BCA ASSESSMENT REPORT

Building 2A, Oakdale West Estate, Kemps Creek

Revision 2

Date: 15 October 2021

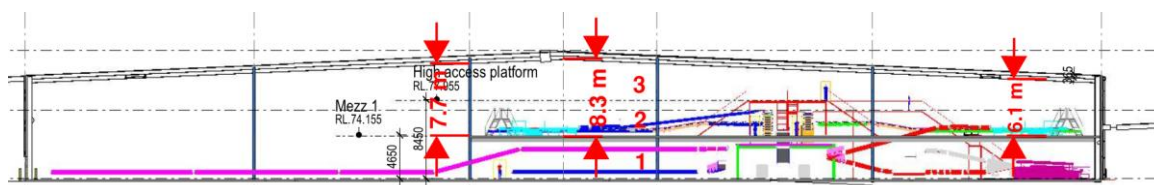
Comments: The proposed warehouse building has a rise in storeys of 3, as a result of the new mezzanine structures in the SE and SW corners of the building.

The average internal height above the Mezzanine 1 and 2 exceeds 6m (see mark-up below) and in accordance with C1.2(c) the area above the mezzanine must be counted as 2 storeys.

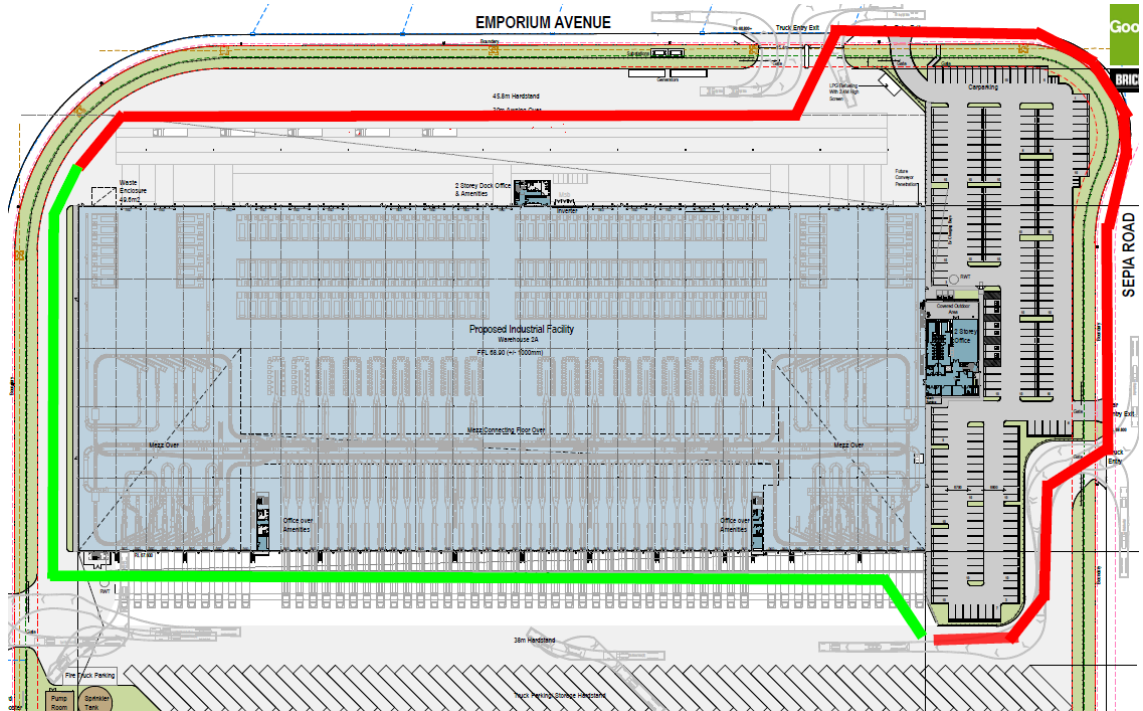
Comments: The proposed building complies with the provisions of C2.4, with the exception of the following non-compliances (shown in red on the mark-up below):

- The perimeter vehicular access on the eastern side of the of the building via the truck entry and Sepia Rd is located greater than 18m from the external walls of the building (shown in red below).
- The perimeter vehicular access on the northern side of the of the building via the hardstand is located greater than 18m from the external walls of the building due to the 30m super awning located on the side of the building and passes under the awning in the NW corner of the site (shown in red below).

Note: The DtS compliant perimeter vehicular access is shown in green in the mark-up below.
